## ADDENDUM #1

AUDREY J. WALTON STADIUM  
TRACK AND SOCCER SURFACE UPGRADE

PROJECT NUMBER: CP252172

Crockett Engineering Consultants  
1000 W. Nifong Blvd, Bldg #1  
Columbia, Missouri 65203

SHEET:  
CE 0.0

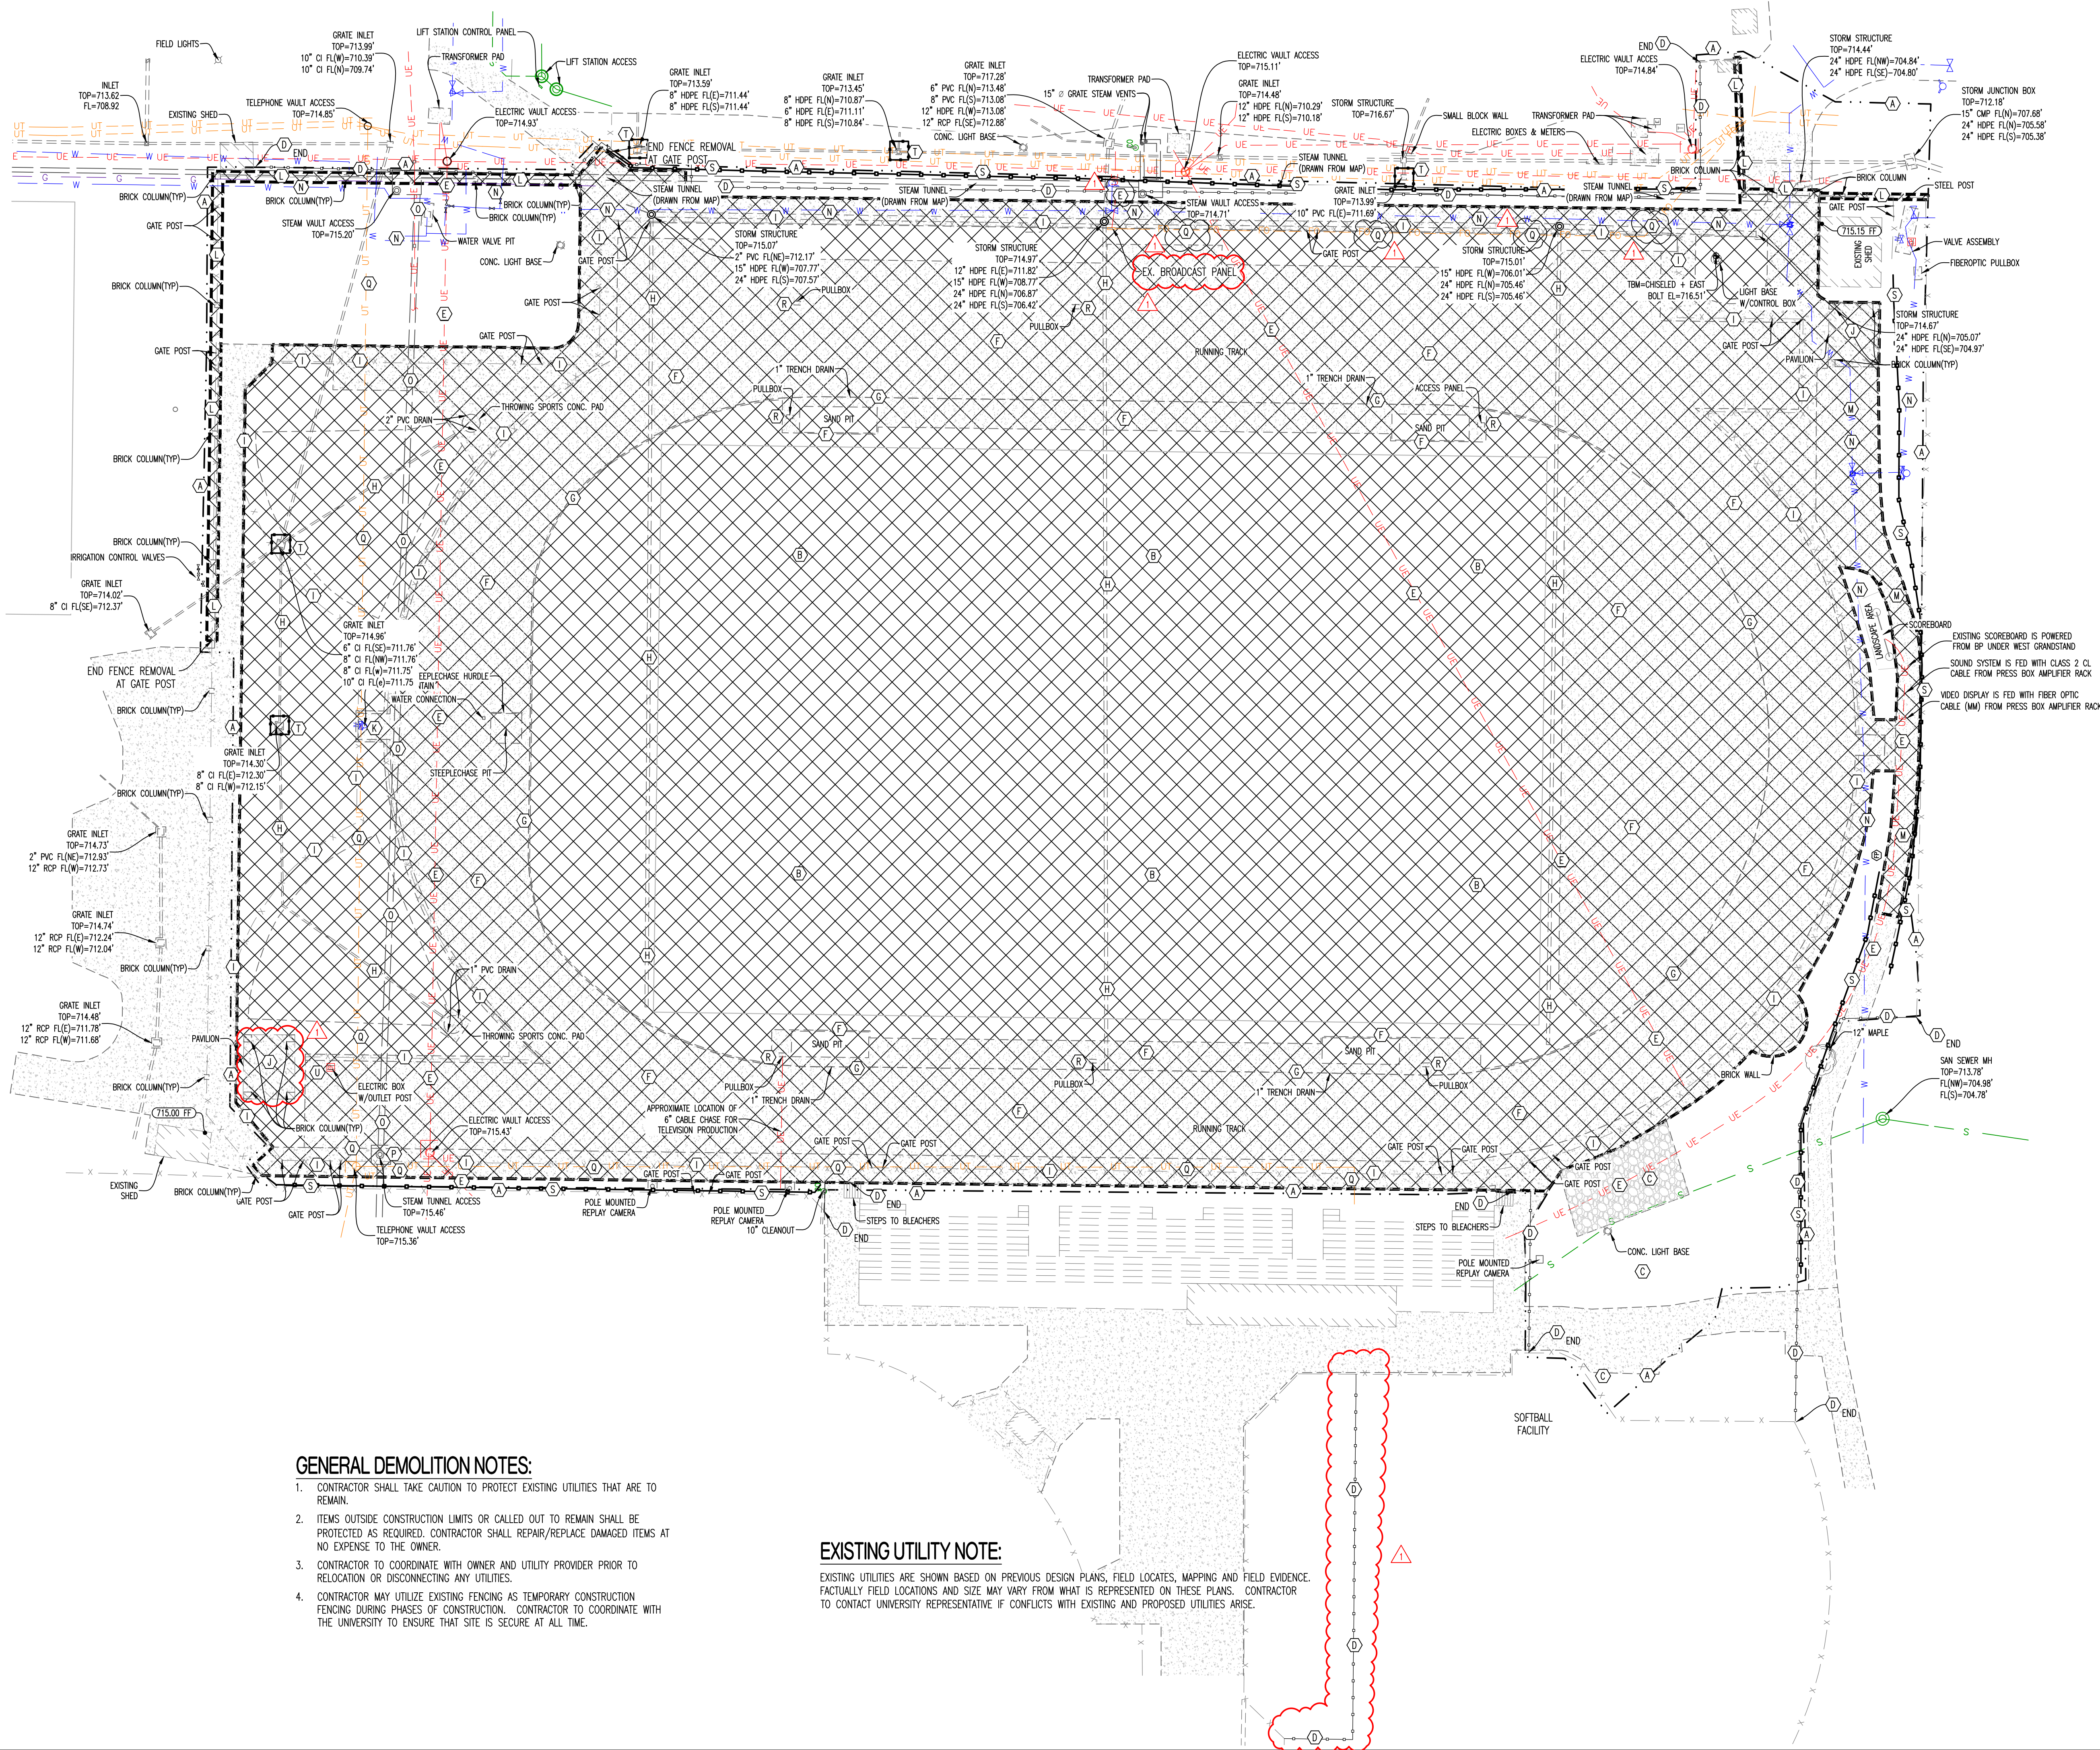
1. Comment: Please confirm the pavilion foundations are in the base bid and not Alternate 3 as noted on CE 0.0 and S200.

The cover page (CE 0.0) has been revised to remove Alternate 3 – Pavillion from the Alternatives section. The Deferred Submittals section has also been removed on same sheet as has the Special Inspections. Sheet S100 has been updated to remove any notes and details pertaining to any pavilion structure. Sheet S200 has been updated to show only the proposed footings that shall be included in the Base Bid. The location of the footings as shown on Sheet CE 6.0 and labeled as Note “T” remain the same.

1. Sheet CE 0.0 – Removal of Alternate 3 and other information (special inspections) pertaining to the future pavilion.
2. Sheet CE 2.0 – The addition of a “J” label on the existing pavilion at the northwest corner of the site. Addition of construction fencing on former softball field.

SHEET: CE 2.1

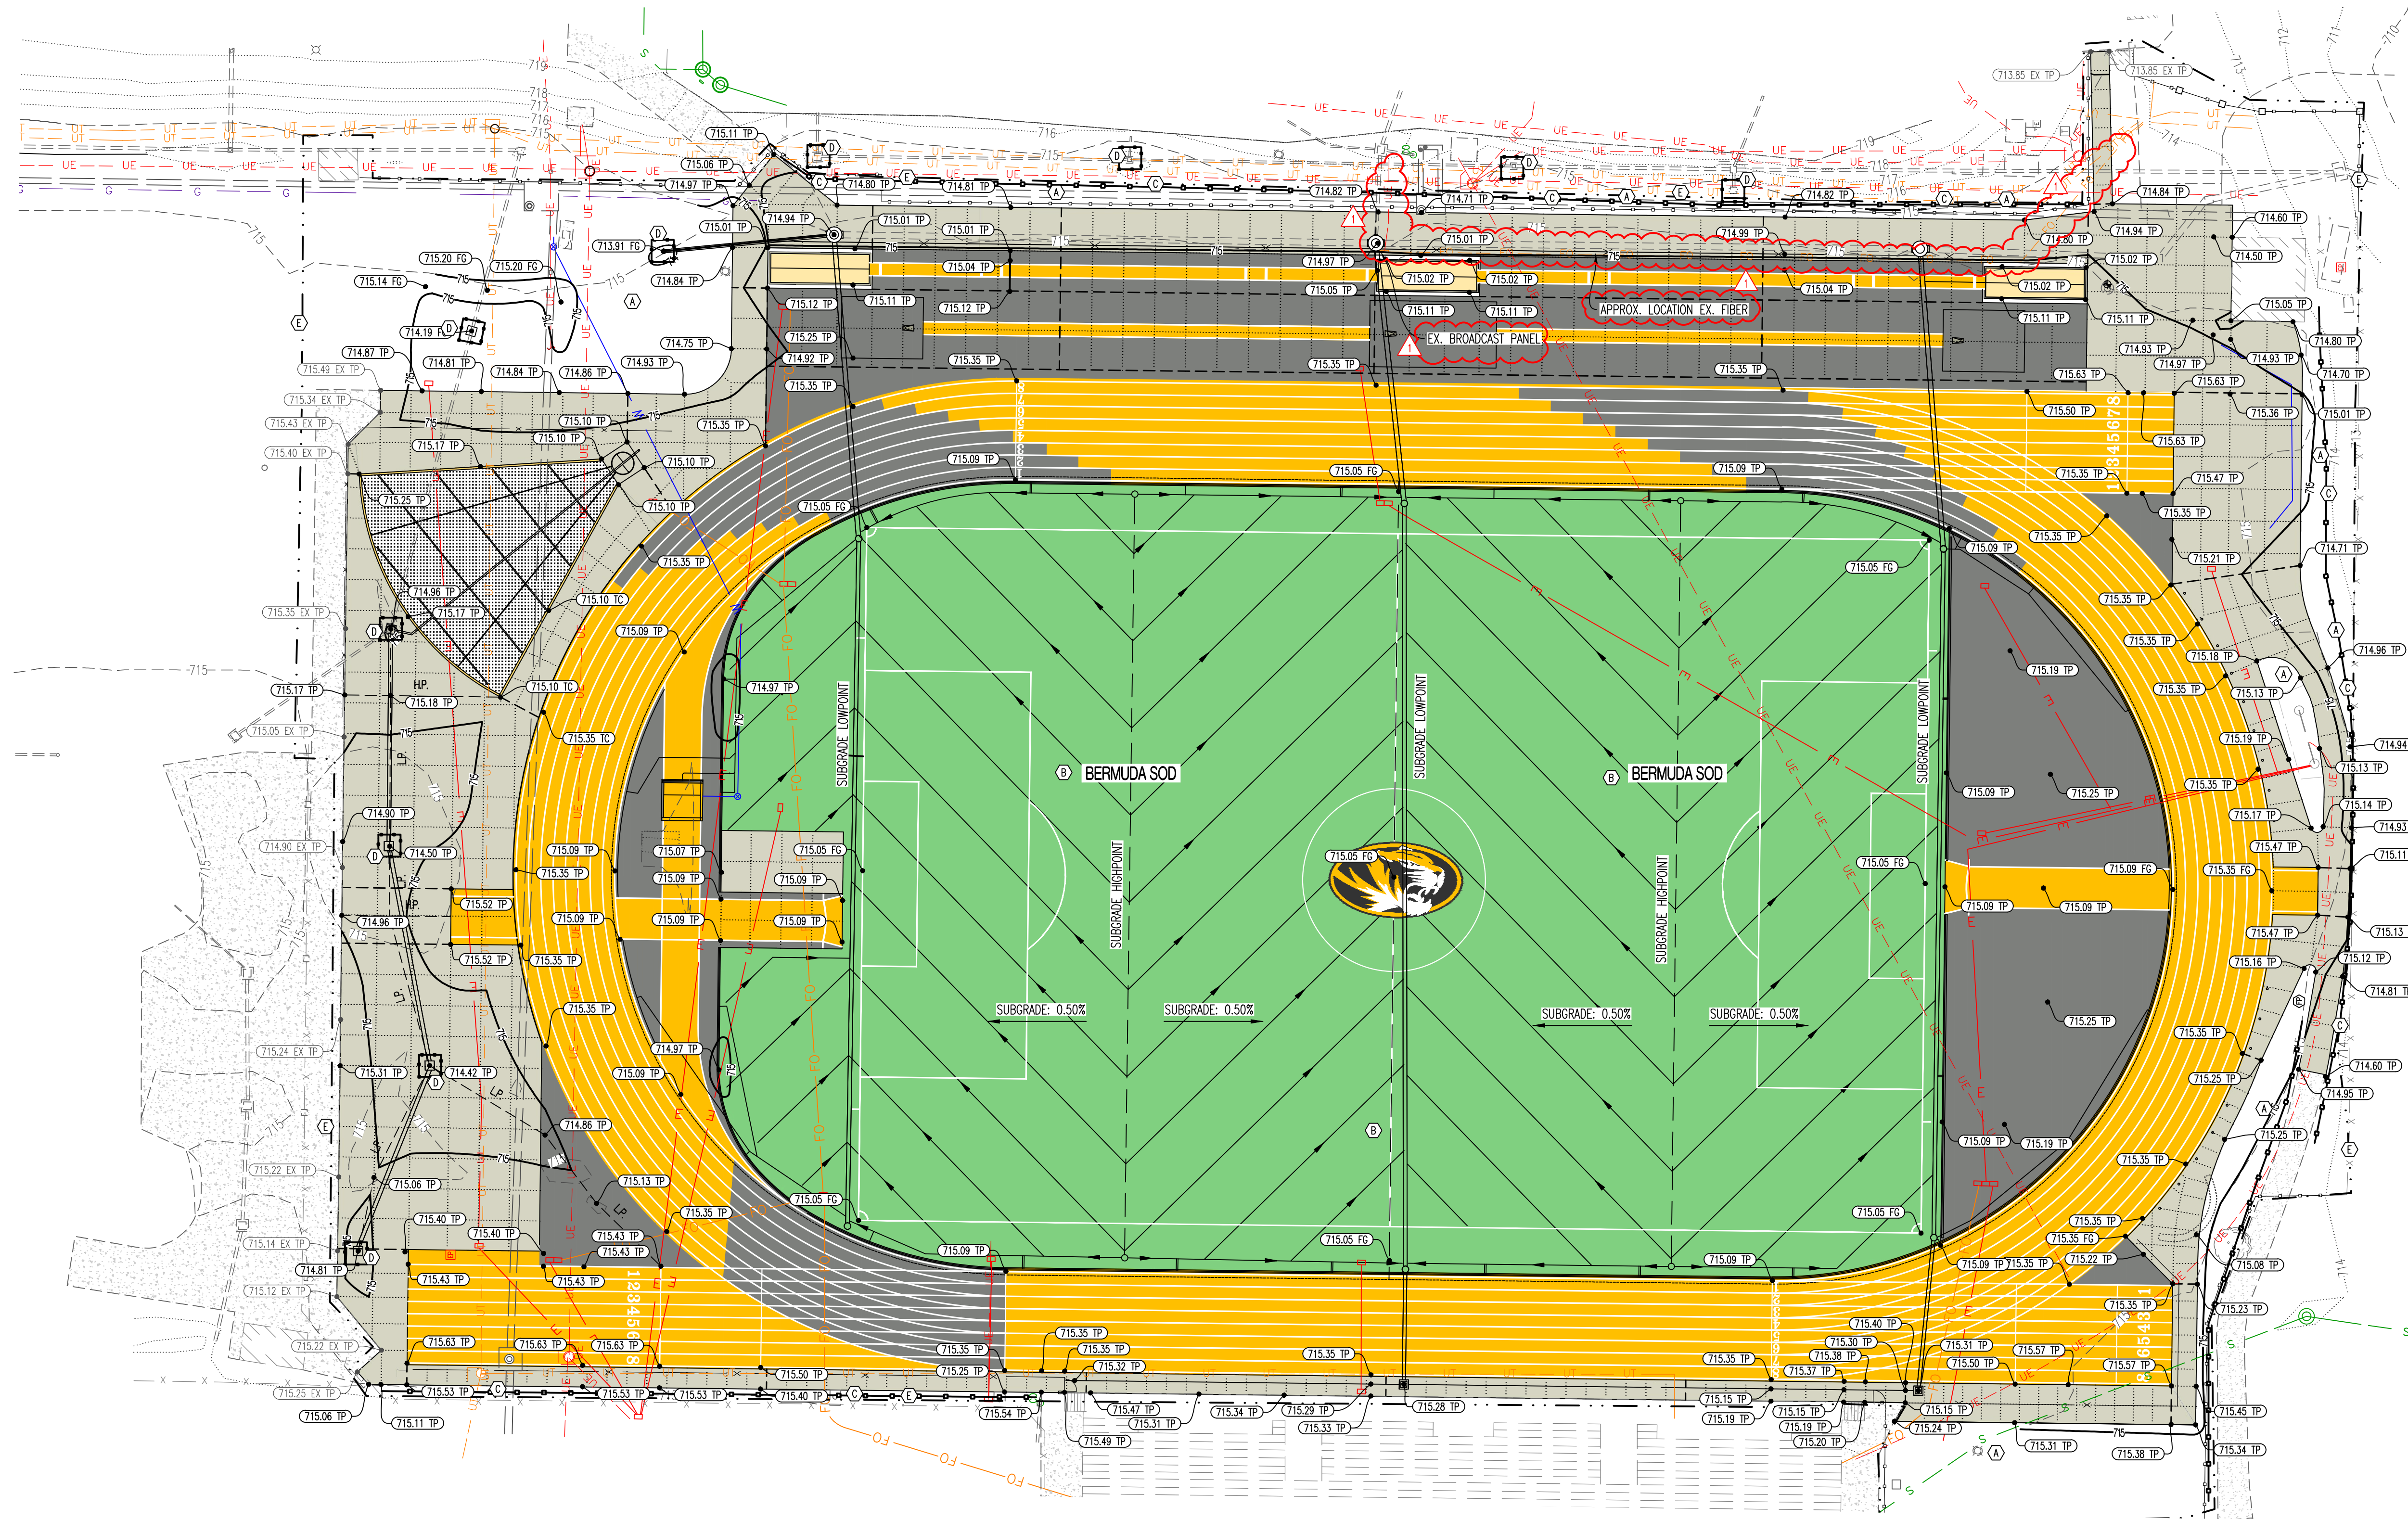
6. Comment: Does the access road need to be removed after construction? What needs to be done to the softball field after construction? How long can the softball field be used and are there any intermittent periods of use for the softball field?

The temporary access road across the softball field, as noted on Sheet CE 2.1, Note “C” will need to be removed by the contractor at the end of the project. The areas used for this access road, as well as the surrounding area used for the laydown area, shall be fine graded by the contractor with all granular material removed. The contractor does not need to seed or mulch these areas. Access through and use of the former softball field shall be available to the contractor throughout construction. There are no non-usable dates for this portion of the project.

3. Sheet CE 2.1 – Addition of construction fencing on former softball field.
4. Sheet CE 4.0 – The realignment of notes R-W in the note section. The elimination of Note T (left blank now) . The addition of Note X regarding adjustment of water valve risers. The revision of Note P reducing the number of bases for the relocated poles.

GRADING AND FINAL  
EROSION CONTROL  
PLAN

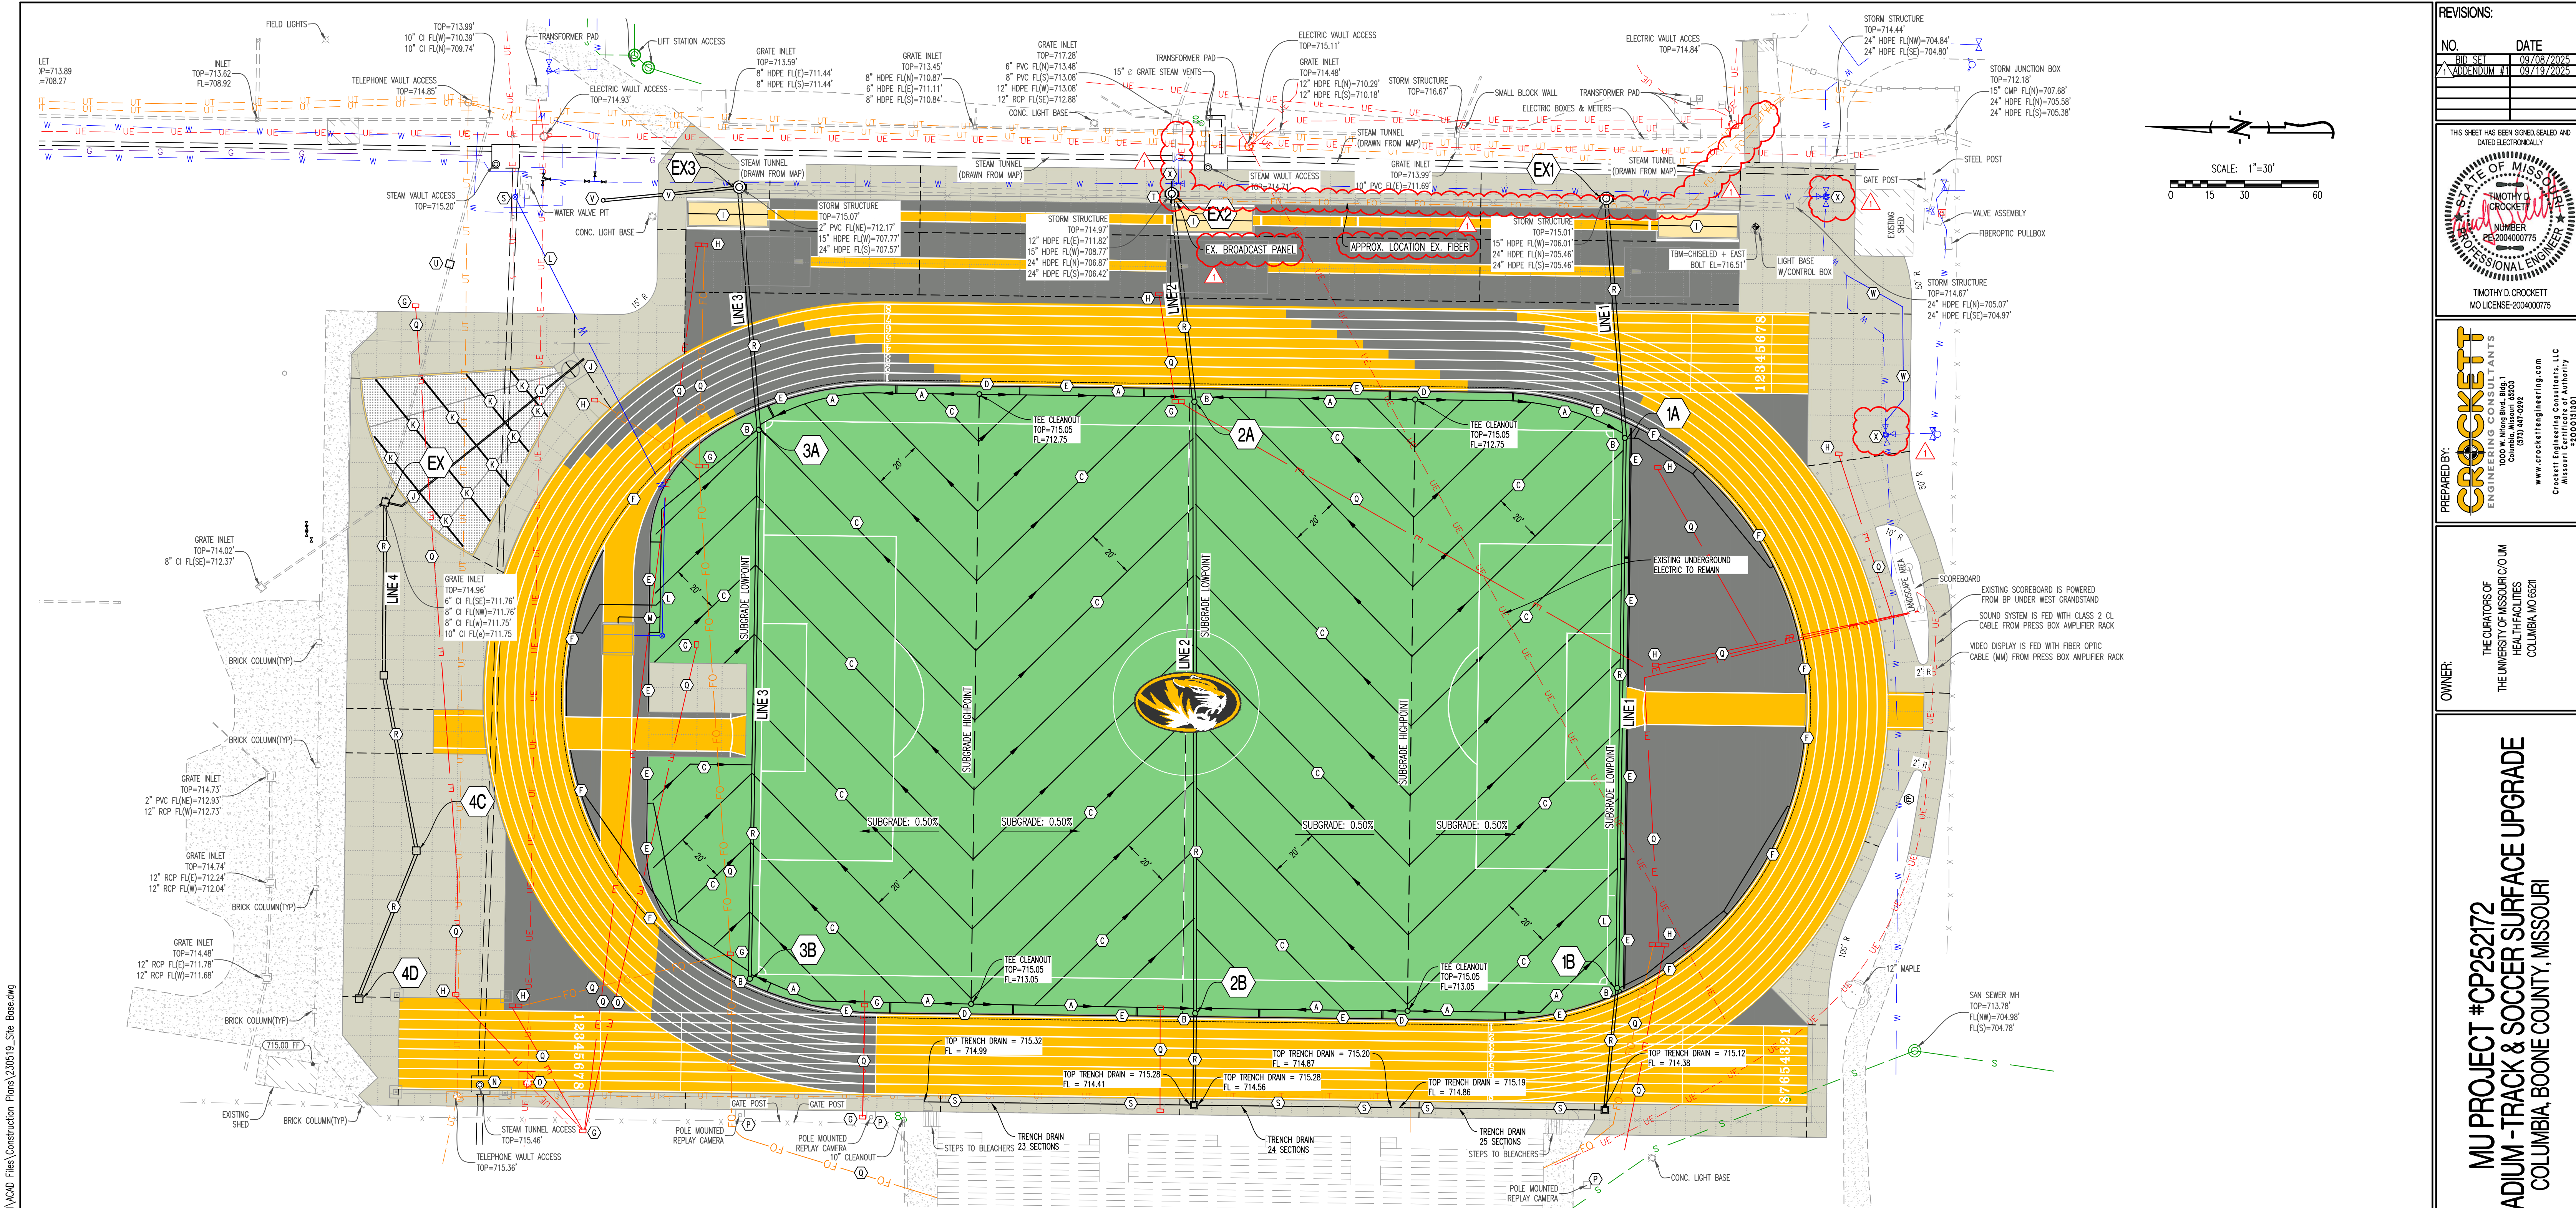
35. Contractors are advised that Note X has been added to Sheet CE4.0 pertaining to the adjustment of the water valve boxes.
36. Contractors are advised that Note T on Sheet CE4.0 has been removed. The note is listed as intentionally left blank. The panel will remain in its current location now.
